DRAINAGE CONDITION DISCHARGE

Document Reference. 21458-CCL-LS-002

Planning Application No	137467/JO/2023
Site Location	32-34 Laystall Street, Manchester.
Description	Erection of 9 storey residential building (Use Class C3) comprising 89 residential units (28 x 1 bed and 61 x 2 bed) and conversion of and 3 storey extension to 32-34 Laystall Street for use as offices (Class E) with associated external works following demolition of outrigger and associated structures along with other associated works including access, servicing, landscaping and secure cycle parking.
Applicant Name	Great Places Housing Group

LLFA Drainage comments.

4. Overland Flow Plan

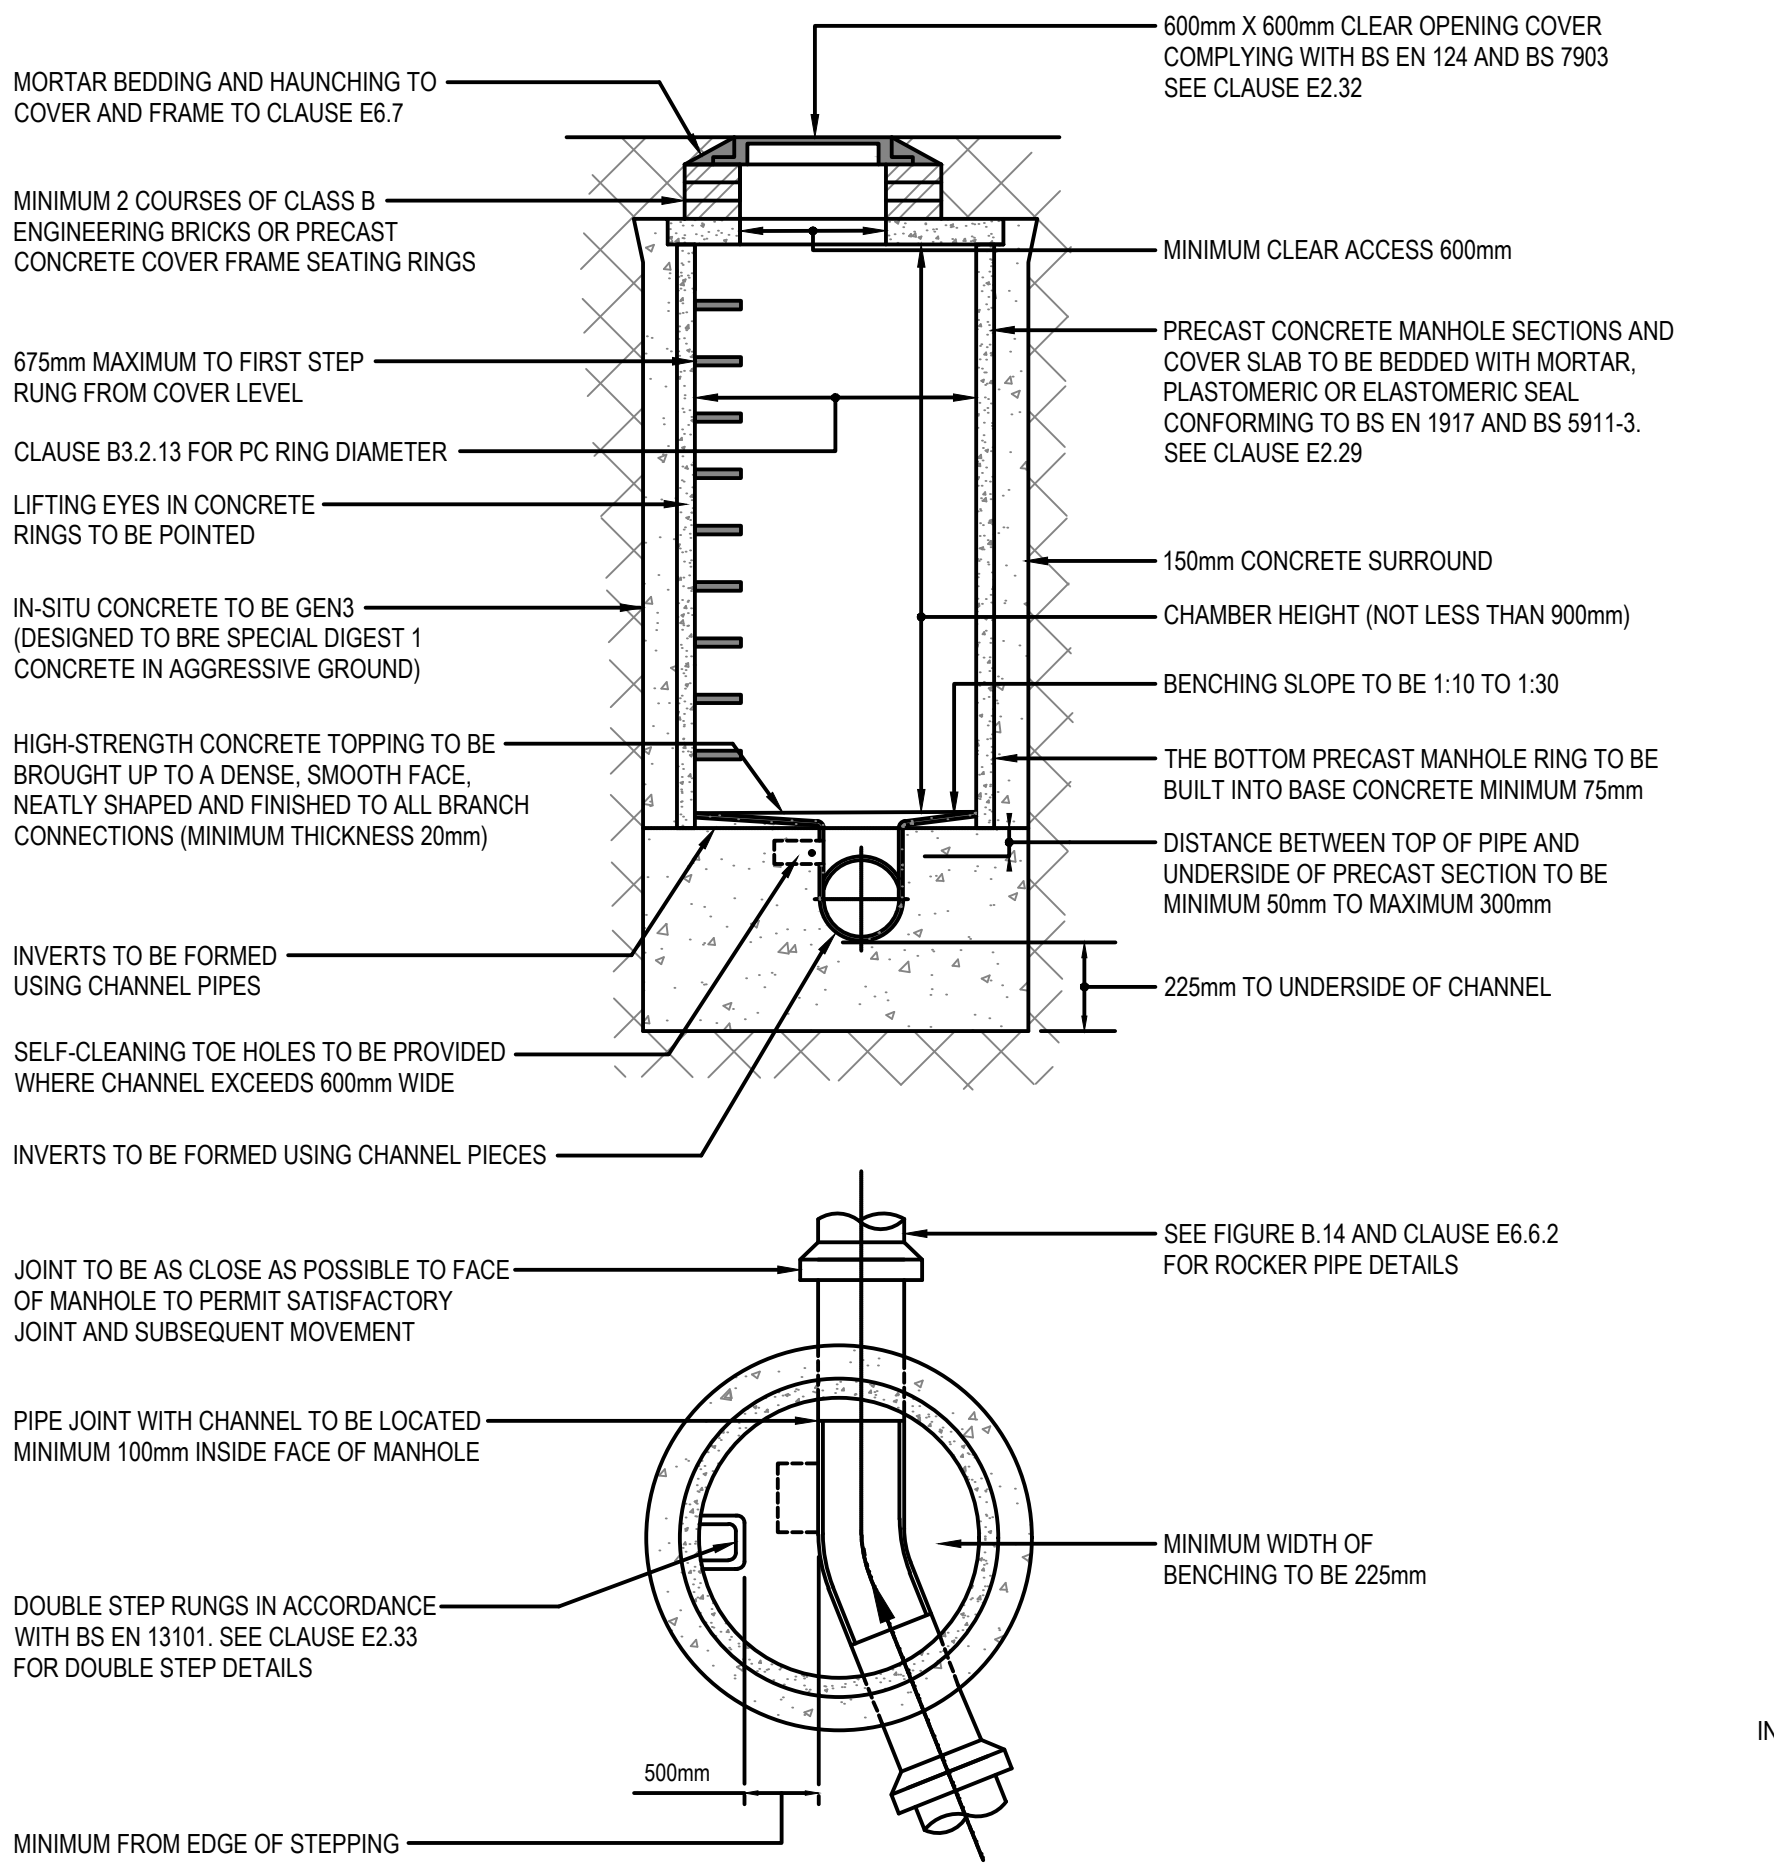
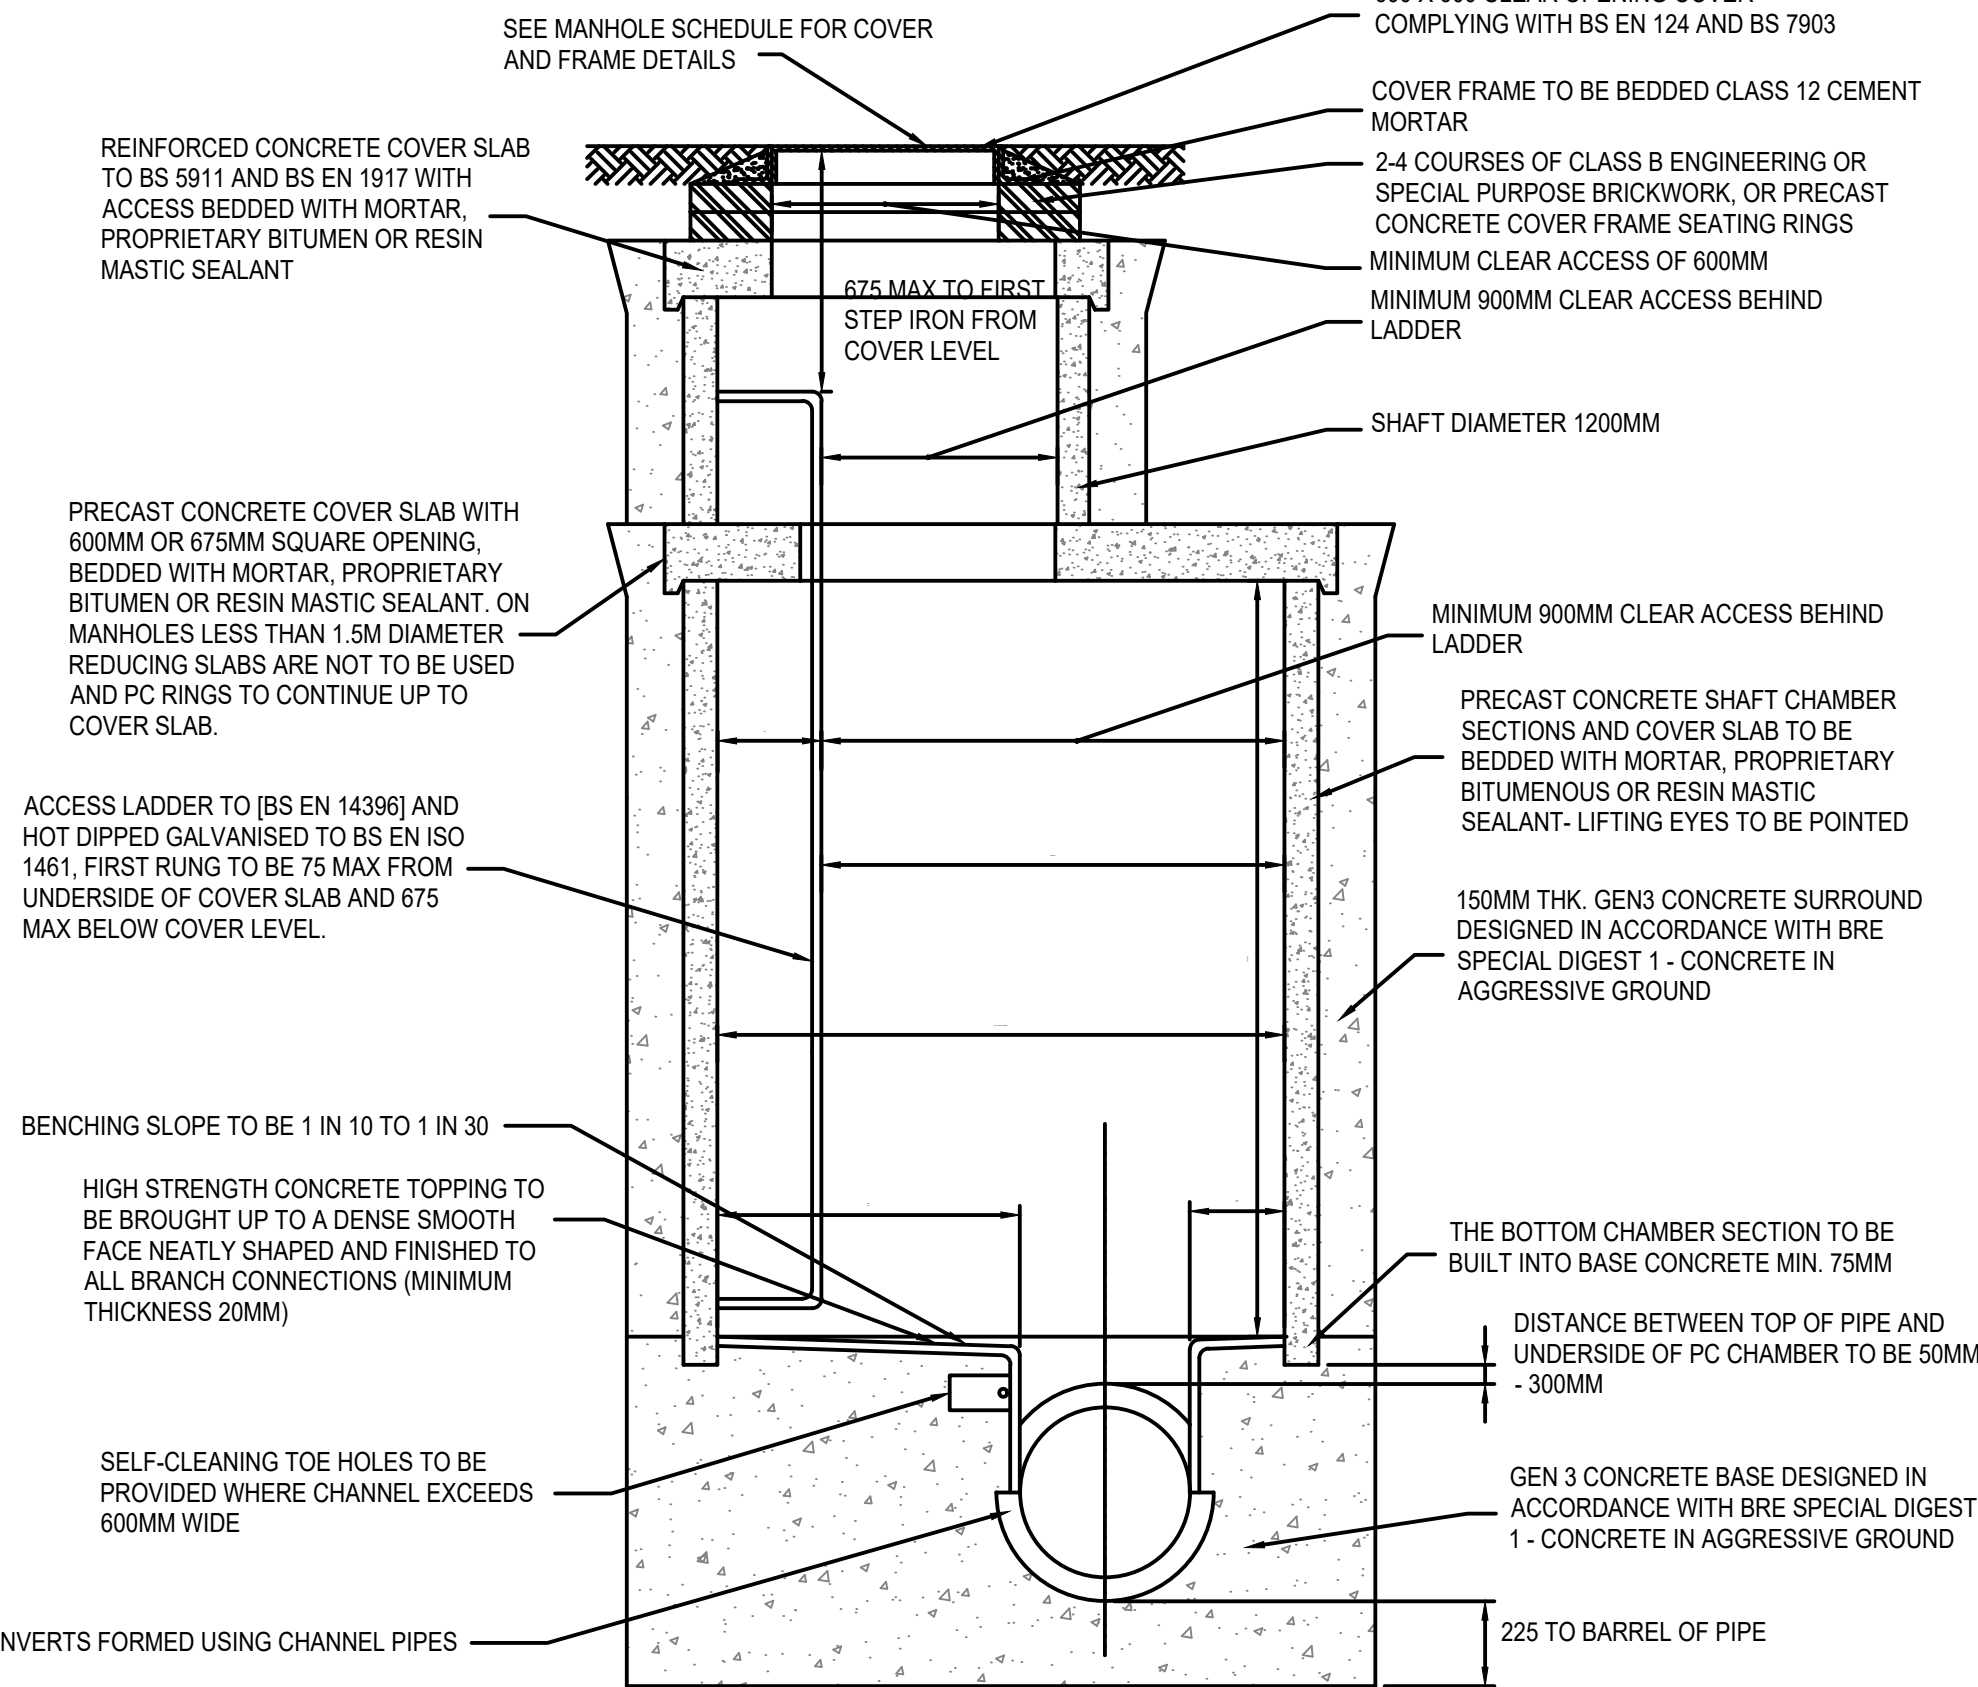
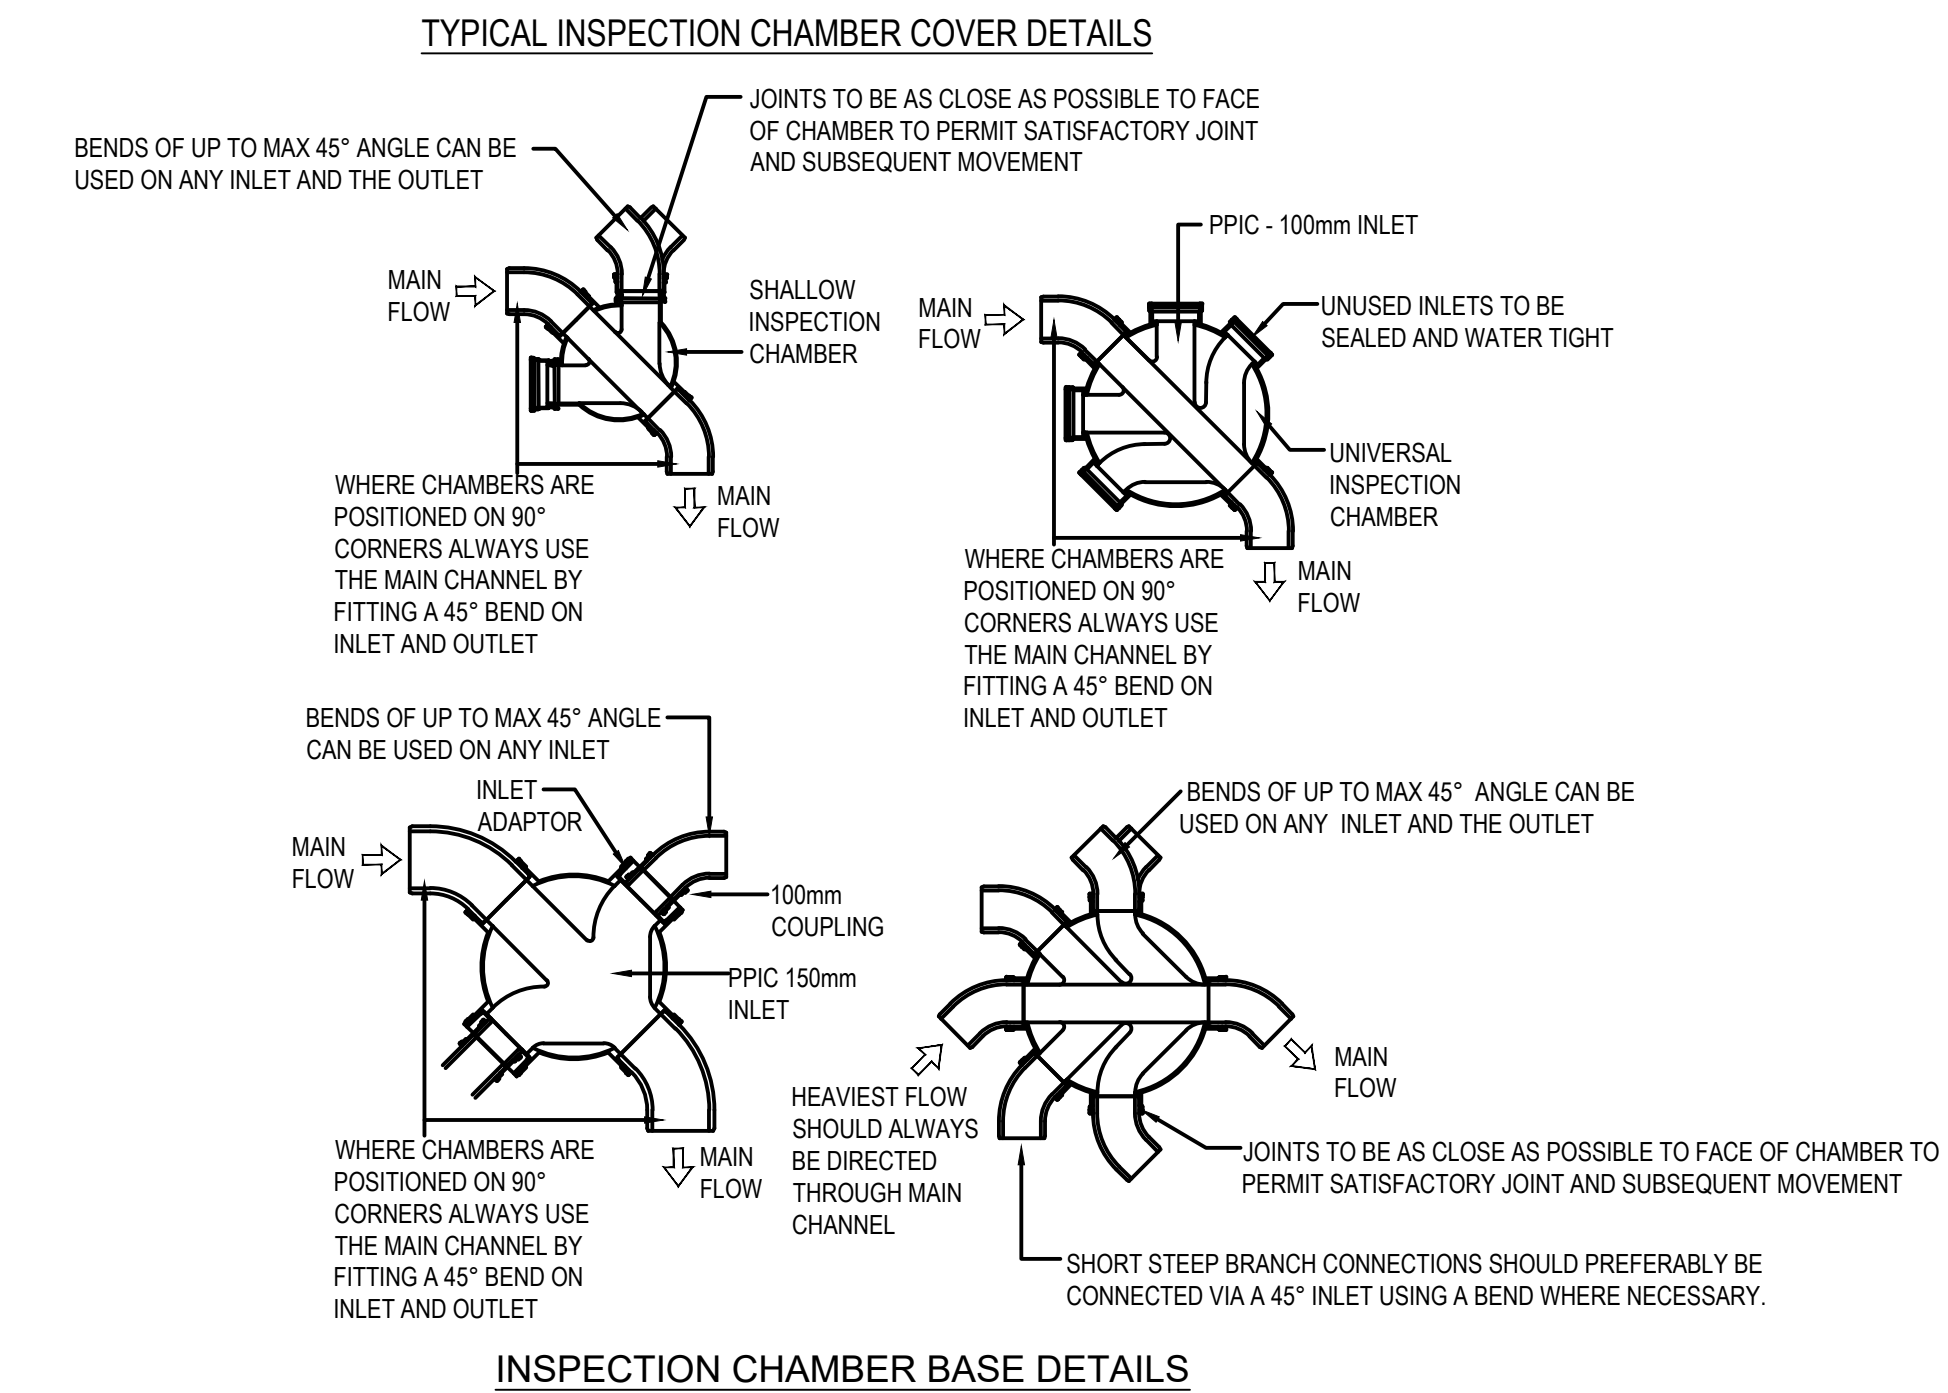
5. Assessment of overland flow routes for extreme events that is diverted away from buildings (including basements). Overland flow routes need to be designed to convey the flood water in a safe manner in the event of a blockage or exceedance of the proposed drainage system capacity including inlet structures. A layout with overland flow routes needs to be presented with appreciation of these overland flow routes with regards to the properties on site and adjacent properties off site.

Refer to Overland Flow Path drawing appended to the back of this document.

With regards to the courtyard area, given that the basement level is c.1.5m below road level (Brock Street), should a blockage occur preventing surface water discharge, the basement could potentially receive flood water. Given the impermeable catchment size of this area (94m²), this has been considered as low risk. Providing maintenance of on-site drainage is carried out in accordance with the drainage maintenance strategy, and United Utilities maintain their public sewer assets, the risk to flooding due to blockage has been considered as low risk.
